REQUEST FOR INFORMATION NOT ADDRESSED IN THIS CCO REMAIN IN FORCE					
(1)	03/30/09	SERVICE PLATFORM ELECTRICAL CHANGES	RR MP	RG FW	55
MARK	DATE	DESCRIPTIONS	BY	CH'D	CCO#
REVISIONS

CONTRACT CHANGE ORDER NO._____
SHEET _____ OF _____

DETAILS
SAS SUPERSTRUCTURE ROADWAY EASTBOUND PANEL UP-206 SCHEDULE
NO SCALE

E-152

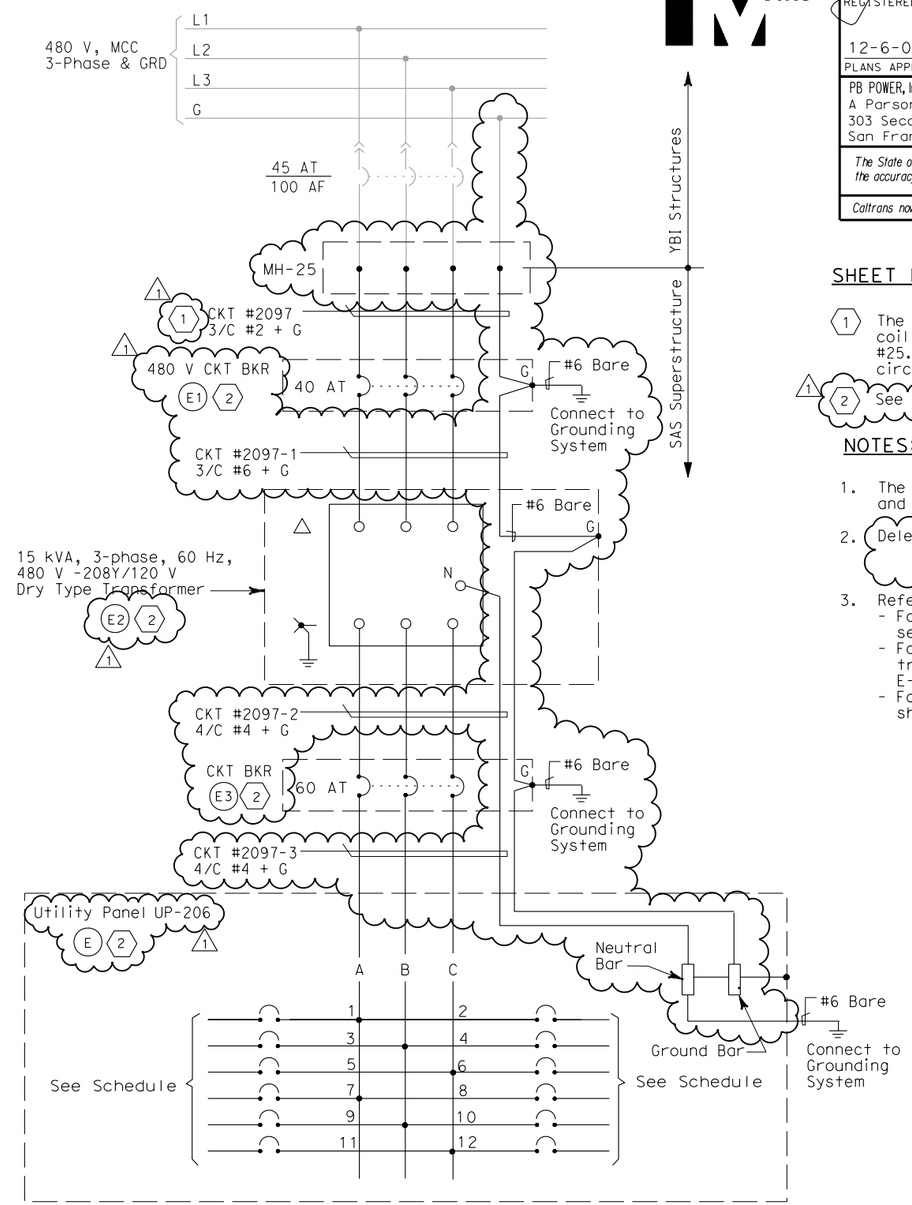
VOLTAGE: 208/120 V
PHASE/WIRES: 3-phase, 4-wire
BUS ~~RATING: 100 A~~
MAIN: MAIN LUGS ONLY (1)
MOUNTING: ~~Surface~~
K.A.I.C.: 10

(1) The Contractor shall extend and coil 5.0 meters of cable in manhole #25. All cables shall be tagged with circuit numbers as shown.

1. The Contractor shall provide nameplates and circuit schedules as shown. (1)
2. Deleted.
3. References:
   - For LVCC-B single line diagram, see sheets E-32 thru E-34.
   - For circuit and conduit/cable tray schedules, see sheets starting at E-401.
   - For pull box schedule, see sheet E-169.
